# Staff Report

To: Salt Lake City Historic Landmark Commission  
From: Caitlyn Tubbs  
(801)-535-7706 or Caitlyn.Tubbs@slcgov.com  
Date: April 7, 2022  
Re: PLNHLC2021-01311

## MINOR ALTERATION – WINDOW REPLACEMENT

**PROPERTY ADDRESS:** 129 West 400 North  
**PARCEL ID:** 08-36-283-009-0000  
**HISTORIC DISTRICT:** Capitol Hill Local Historic District  
**ZONING DISTRICT:** SR-1A and H Historic Preservation Overlay District

Figure 1: Floor plan submitted by Applicant with Staff annotations of replaced windows.

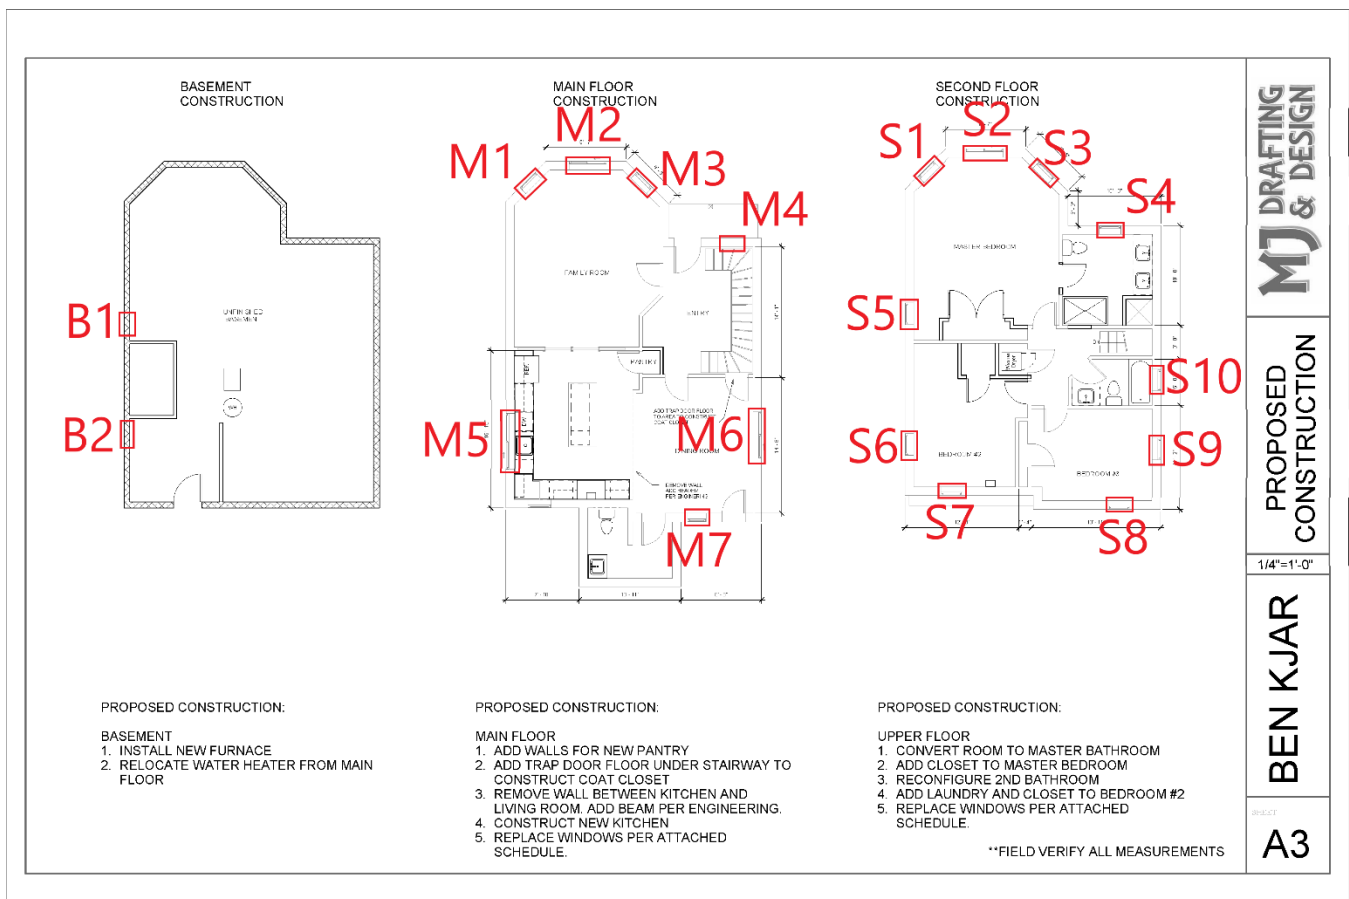
The Applicant has replaced multiple windows in the historic home as shown in the image above; the windows which were replaced are outlined in red. A number of these windows (B1, B2, M6, M7, S5, S6, S7, S8, S9, and S10) are not readily visible from the public right of way and could be eligible for an administrative approval, however, Staff has found the windows on the front façade do not meet the standards of approval and has forwarded the entire request to the Historic Landmarks Commission.

Windows B1, B2, M6, M7, S5, S6, S7, S8, S9, and S10 are located on secondary façades and are not readily visible from the public right of way. Windows B1, B2, S5, and S6 are located on the western (side) façade. The surrounding homes are built closely enough to the subject structure that the windows on the secondary façades are not easily seen. Windows M5 is also located on a secondary façade, however, these windows are shorter than the originals and the opening in the façade has been enclosed with a wooden board. Changes to the opening sizes within the brick itself is highly discouraged by the standards so these windows are not appropriate. The Residential Design Guidelines prohibit the increasing or decreasing the sizes of the openings in the façades and these windows should be replaced with a window that is the same size as the originals and the pre-existing opening. Windows S10, S9, and M6 are located on the eastern (side) façade and are even more difficult to see from the public right of way, these windows are appropriate for their locations in the building. Additionally, windows M7, S7, and S8 are located on the rear of the building and are not visible at all from the public street. Therefore, these windows are appropriate.

**RECOMMENDATION:** Upon review of the proposal and the applicable standards and ordinances, Staff recommends the Historic Landmark Commission approve the request for a Certificate of Appropriateness in part for replacement of All of the windows on the eastern (side) and southern (rear) facades, and for windows B1, B2, S5 and S6 on the western (side) façade; and deny the request for a Certificate of Appropriateness in part for replacement of the windows on the northern (front) façade and for window M5 on the western (side) façade as diagrammed herein.
